UNITED STATES PATENT AND TRADEMARK OFFICE

| APPLICATION NO. | FILING DATE | FIRST NAMED INVENTOR | ATTORNEY DOCKET NO. | CONFIRMATION NO. |
|-----------------|-------------|----------------------|---------------------|------------------|
| 09/779,169 | 02/08/2001 | Eric P. Orgeron | A99274US (98062.3) | 6510 |

DETAILED ACTION

FIGURE 1

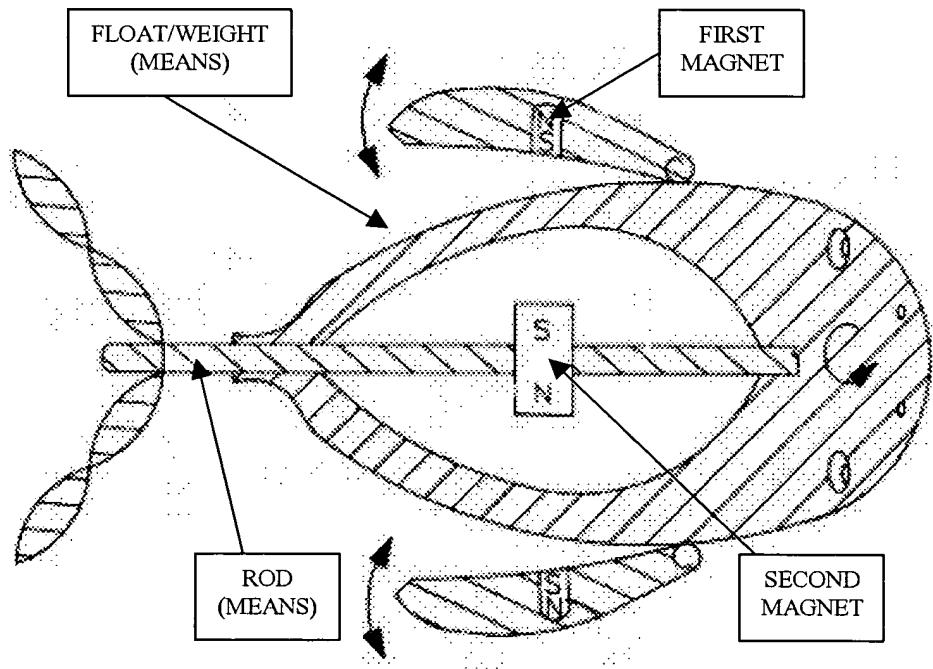
Claim 9 is rejected under 35 U.S.C. 102(e) as being clearly anticipated by Preston.

In regards to **claim 9**, Preston teaches an apparatus for making a sound similar to the slapping or clicking noise that a live shrimp makes when the tail section of the live shrimp makes contact with its body section comprising: a float (11) slidably received on a rod (16), a first magnet (24) attached to the float (11) and a second magnet (14) attached to the rod (16). The first (24) and second (14) magnets are aligned such that they repel one another (see col 2, lines 52-55). See Figure 1 below.

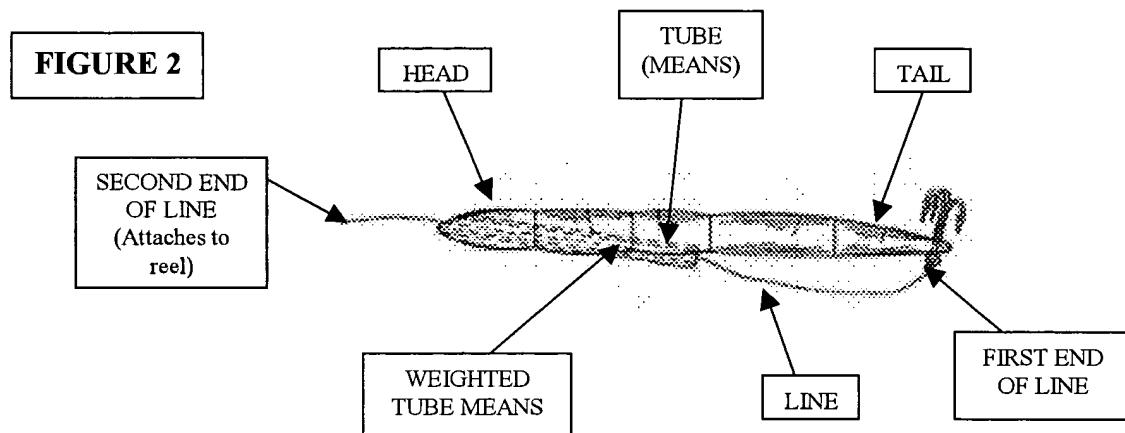
Claims 18-24, 26-27, 31-34 and 39-40 are rejected under 35 U.S.C. 102(b) as being clearly anticipated by Brokaw.

In regards to **claim 18**, Brokaw teaches a fishing lure (2c) for use in water with a fishing line comprising an artificial bait body (unnumbered) having a tail (10) and a weighted tube means (50) in the body for allowing a line (14) to pass from the tail (10) of the artificial bait body (unnumbered) through the tube means (50) and for causing the artificial bait body to be at a level position in the water while hanging on a fishing line. See Figure 2 below.

Regarding **claim 19**, Brokaw discloses a fishing lure (2c) further comprising a line (14) passing from the tail (10) of the artificial bait body (unnumbered) through the weighted tube means (50).

In regards to **claim 20**, Brokaw teaches a fishing lure (2c) wherein the artificial bait body (unnumbered) has a head (8). The lure (2c) also has a weighted tube means (50) in the artificial bait body (unnumbered) positioned forward of the tail (10), generally in between the head (8) and the tail (10). The lure further comprises a flexible fishing line (14) or leader having first and

second ends (unnumbered). The first end of the fishing line (14) is attached to the tail (10) of the artificial bait body (unnumbered) and the line (14) passes through the weighted tube means (50) wherein the second end of the fishing line (14) is connected to a fishing reel or to a length of fishing line wound upon a reel. See Figure 2 above.

(unnumbered) is a tube for allowing a line (14) to pass from the tail (10) of the artificial shrimp body through the tube (unnumbered). See Figure 2 above.

In regards to **claim 39**, Brokaw, as modified in claim 28, teaches a fishing lure (2c) further comprising a tube means (unnumbered) in the opening (50) for allowing a line (14) to pass from the tail (10) of the artificial bait body (unnumbered) through the tube means (unnumbered). See Figure 2 above.

In regards to **claim 40**, Brokaw, as modified, teaches a fishing lure (2c) further comprising a line (14) passing from tail (10) of the artificial bait body (unnumbered) through the tube means (unnumbered). See Figure 2 above.
